DRESDEN - UFSAR

9606040014 960530 PDR ADDCK 05000249 (Sheet 1 of 1)

Table 3.8-11

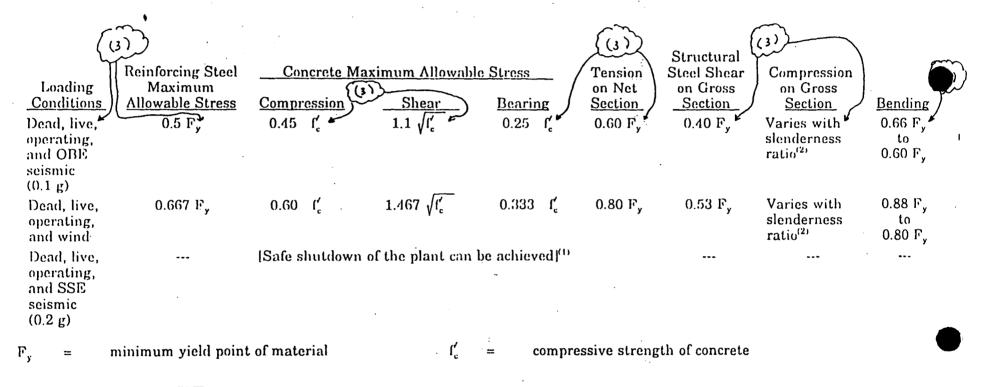
Not applicable to Unit 3 corner room structural steel Until the 3.8-24 structural steel modifications use completed in O3 Riy
